Sent: 9/05/2021 10:44:26 AM
Subject: Development Assessment - REV2021/0014
Attachments: REV20210014 Submission.pdf;

Please see attached our submission on REV2021/0014 (321-331 Condamine Street, Manly Vale).

REV2021/0014

307-319 Condamine Street

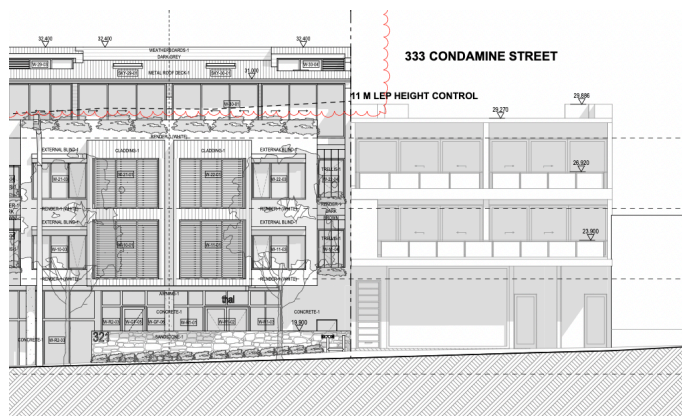
The development further to the south (307-317) uses a compliant design, which steps the height over the incline so its not imposing from Condamine Street and remains 3 storeys as the building inclines. REV2021/0014 is 4 storeys at the front to the back so will be over-scaled to buildings on the southern boundary which is a maximum height of 3 storeys (images below):

View from Sunshine St (3 storey max neighbours)
